RE: Submission of 2018 Geotechnical Inspection Report No. 1 (Jul/Aug. 2018)

BHM Project No. 18-068

ANNUAL GEOTECHNICAL INSPECTIONS

MARY RIVER PROJECT

16. Waste Pile Drainage Containment

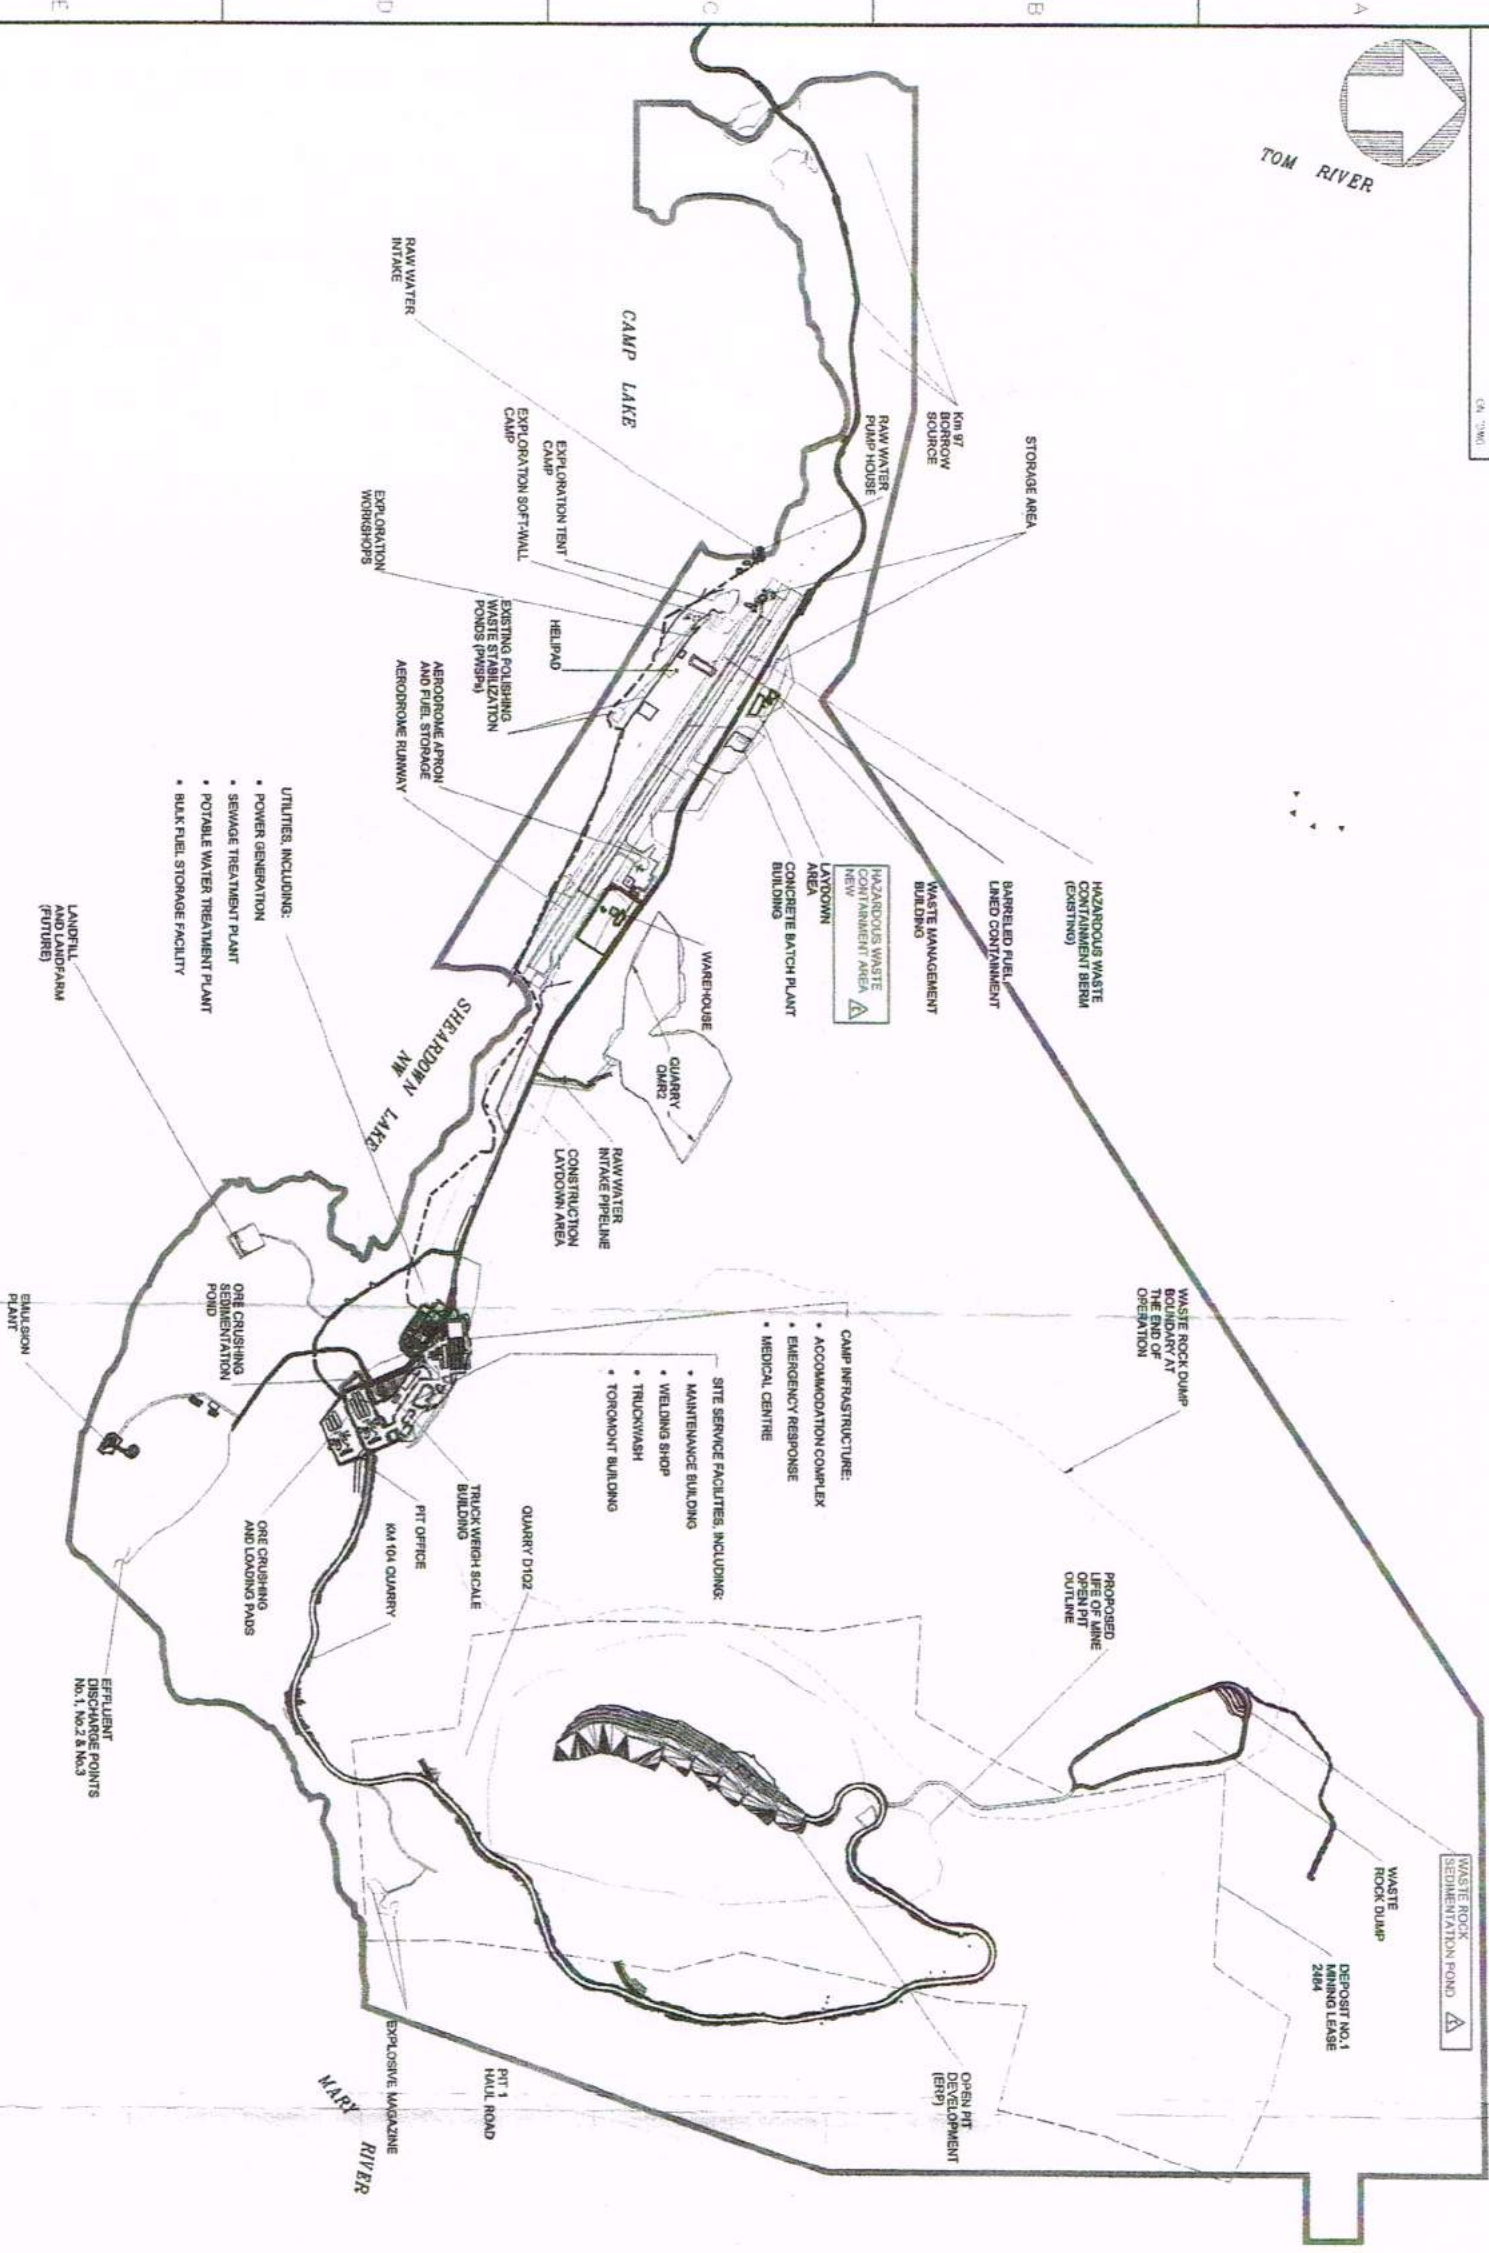
A leak is now apparent from the pond and water is currently percolating through the soil under the dyke. From our observations, we suspect a leak through a welded joint in the liner. This could possibly be at the location where the liner is folded at the interior base of dyke. Further investigation is required.

As the percolation points are not particularly close to each other, there could be more than one leak.
